MINISTRY OF ENVIRONMENT, LANDS AND PARKS

File No. PE-4088

subject: **District of Sechelt Sewage System Upgrades**
 date: June 1, 2012
 meeting date: February 28th, 2012
 location: BC MoE offices - Surrey
 file: 1592.0027.01
 prepared by: Dr. Joanne Harkness, R.P.Bio
 distribution: All attendees

The District of Sechelt has recently received funding to build a new sewage treatment plant. From a meeting held with the BC Ministry of Environment on February 28th, 2012, the direction was set for the new facility to be registered under the MSR. As there have been changes with respect to effluent release to a surface water since the completion of the 2006 environmental impact study, an updated report is required as part of the registration package. The information presented in this report contains much of the 2006 environmental impact study document. However, the following information has been added to the original report:

Figure 4.1: Average Monthly Flow Data (2001 to 2005)

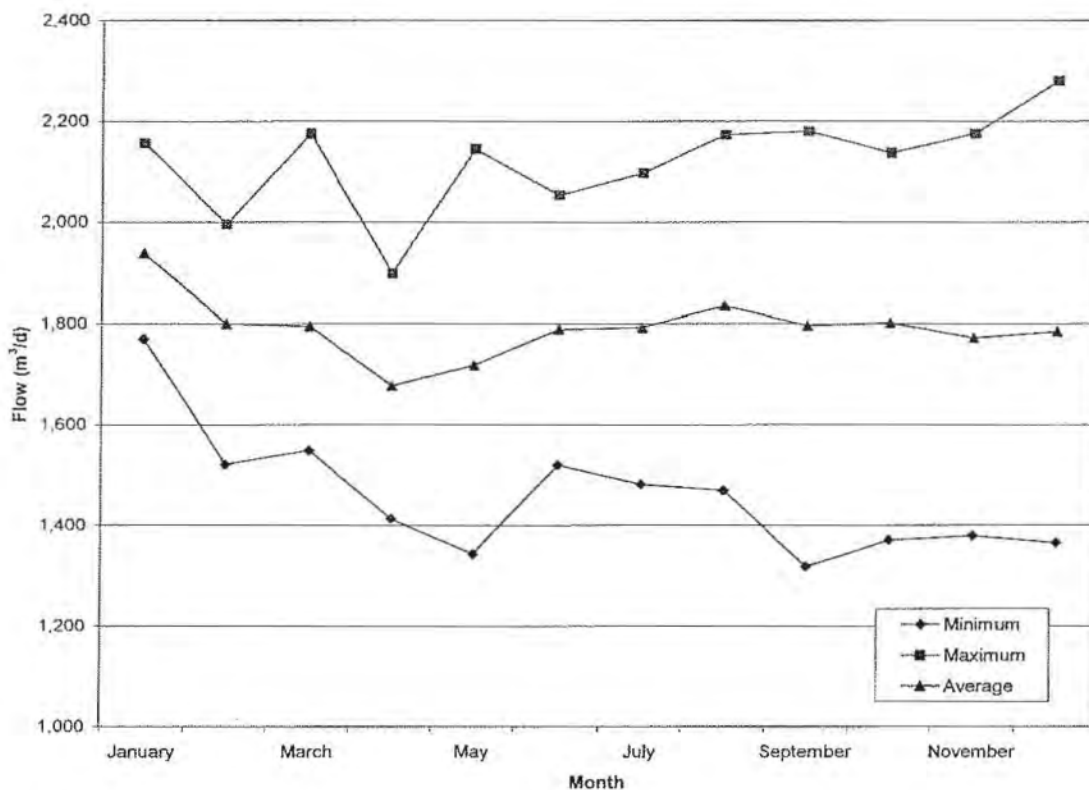
- Page 15 – the current permit maximum of 3400 m³/day in Table 4.1 should be changed to 3740 m³/day;
Question – Does the 324 m³/day influent flow at the Dusty Road plant include the sludge amount received from the Ebb Tide plant?
